single-engine SERVICE LETTER

SE70-32

A MANDATORY INSPECTION AND MODIFICATION OF 177/CARDINAL STABILATOR ATTACHMENT IS IMMEDIATELY REQUIRED BECAUSE OF CRACKING OF ATTACHMENT ANGLES IN SOME HIGH TIME 177/CARDINAL AIRCRAFT.

Title INSPECTION AND REINFORCEMENT OF
STABILATOR ATTACH BRACKETS

Figure 1. Inspection and Replacement of Angles

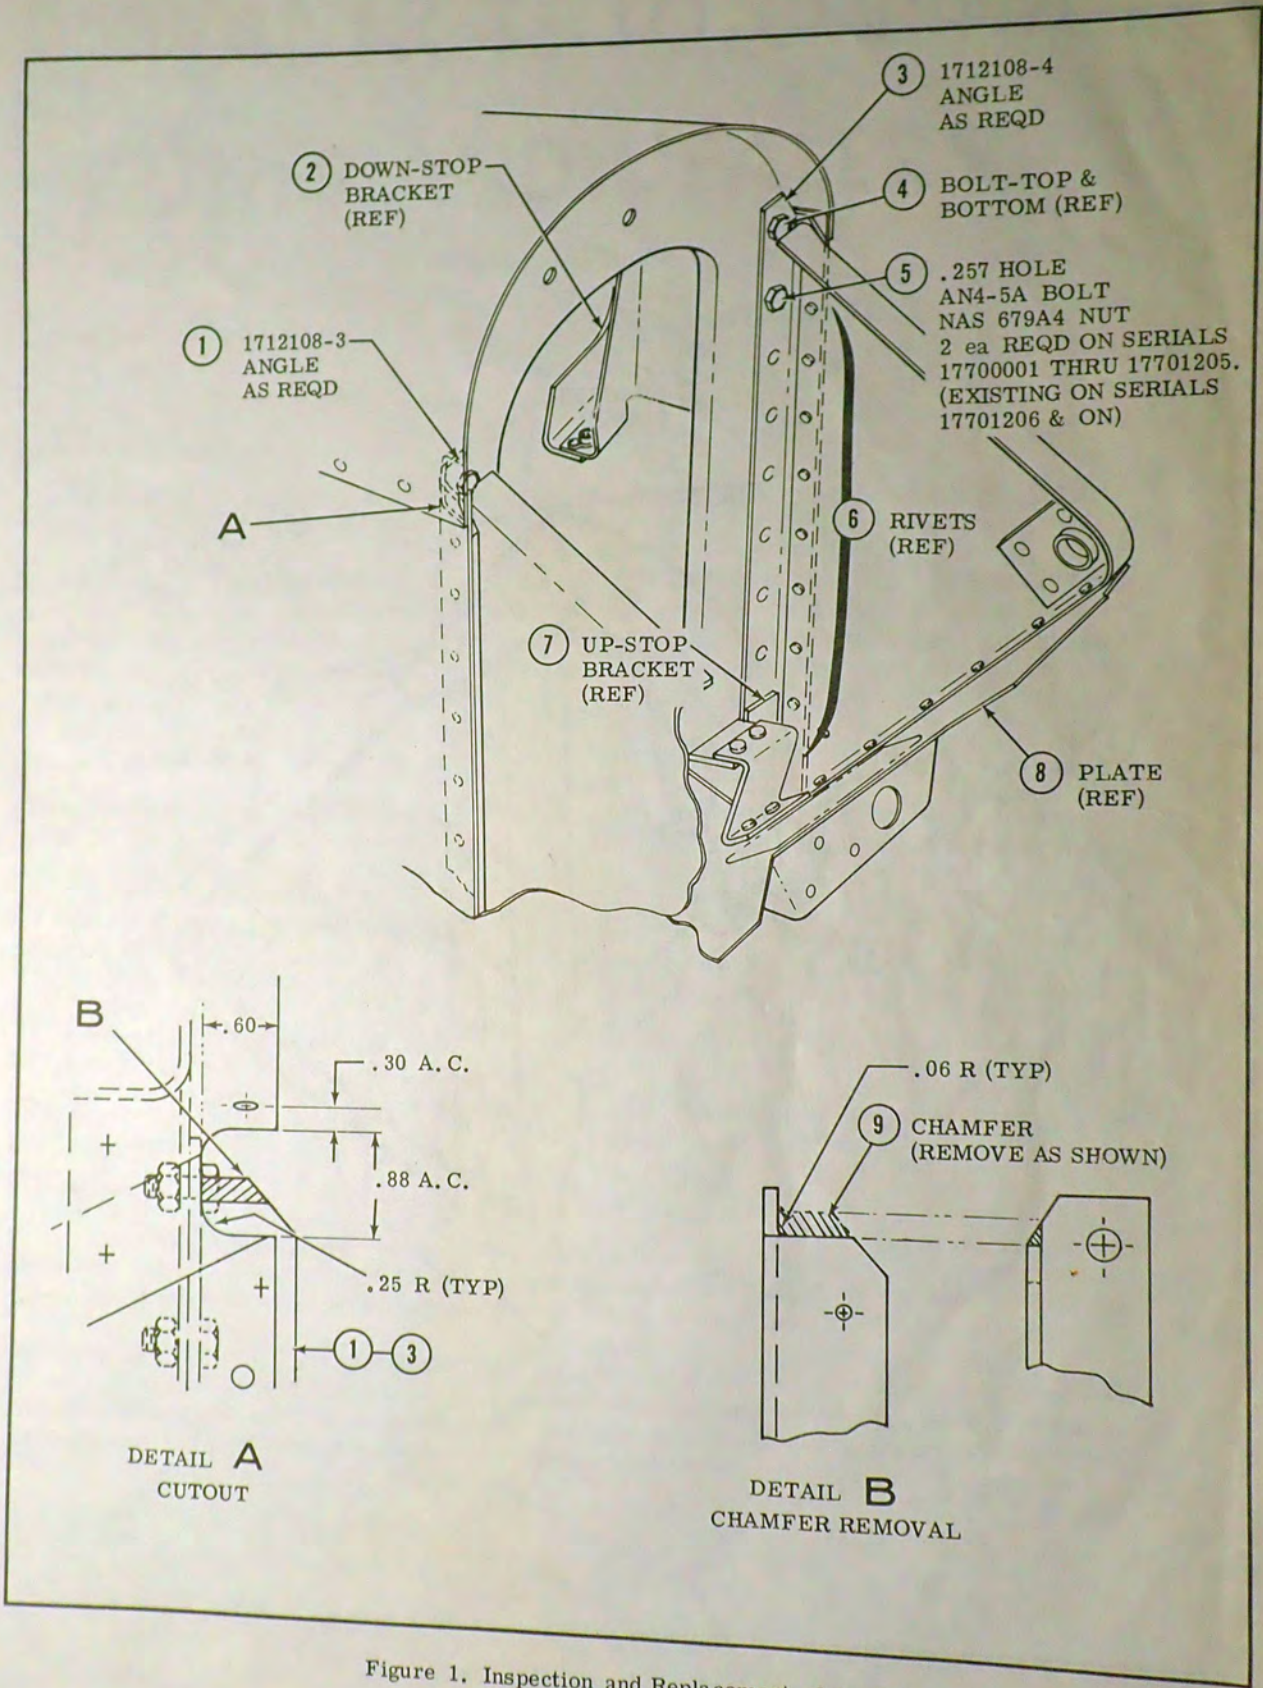
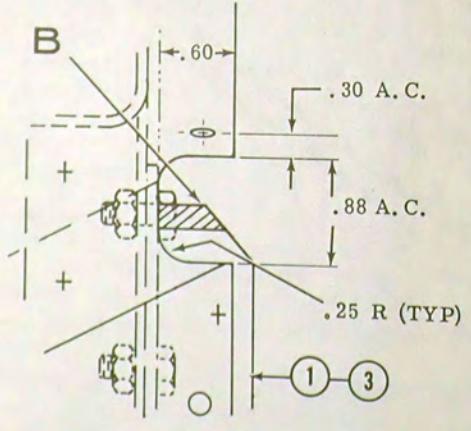
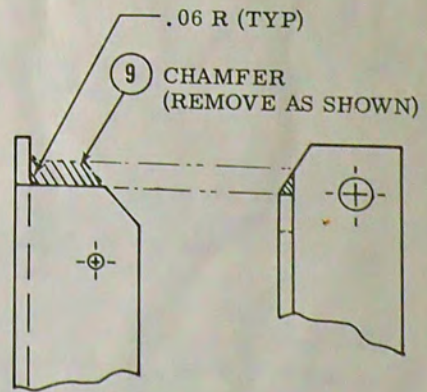
Before further flight, conduct a careful visual inspection of the bracket attachment angles shown in Figure 1 of the attached Service Kit (Items 1 and 3). Pay particular attention to the area around the heads of the top attach bolts (Items 4 and 5).

- (1) Remove stinger and side plates.
- (2) (Refer to figure 1.) To allow inspection access to angles (1) & (3) cut out skin as shown in detail A, on both sides of tailcone.
- (3) Remove chamfer (9) from each angle (1) & (3) as shown in detail B.

- (4) Apply dye check to each reworked area.

If cracks are still present in angles, each angle must be replaced.
Proceed to step b.

- (7) Remove stabilator from aircraft.
- (8) On aircraft serials 17700001 thru 17701165 remove tail skid & bracket assembly from aircraft.
- (9) Remove bottom plate (8) to allow access to lower rivets thru angles.
- (10) Drill out all rivets (6) remove bolts (2) and (5).

If bolt (5) does not exist it must be installed thru second rivet hole on serials shown.

- (1) Install new angles (1) & (3) on stabilator brackets.

Enlarge pilot holes in new angles, UP-STOP and DOWN-STOP brackets to fit rivets & bolts as required, and install lower bolts common to angle and stabilator bracket before riveting angles to brackets.

Figure 2. Stiffener Bracket Installation

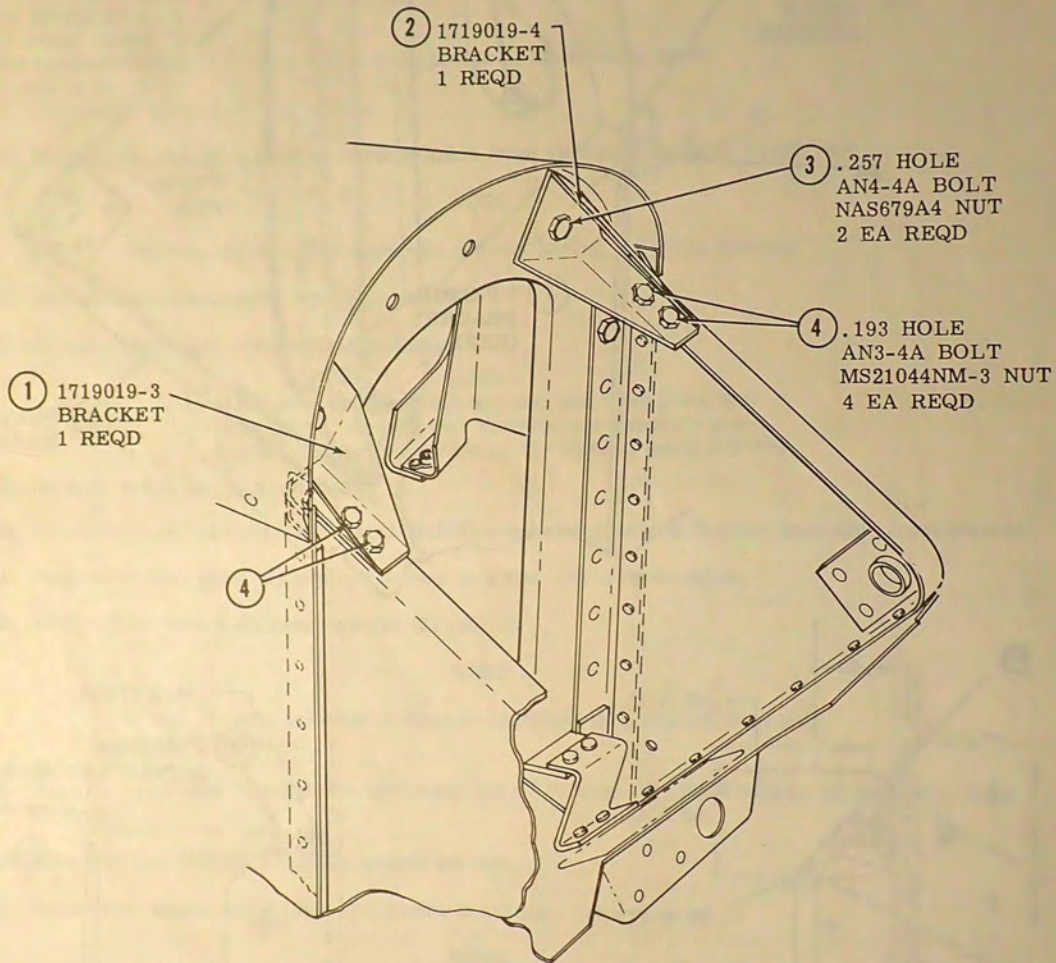
- (2) (Refer to figure 2.) Install reinforcements (1) & (2) as shown.
- (3) Reinstall all previously removed hardware and parts.
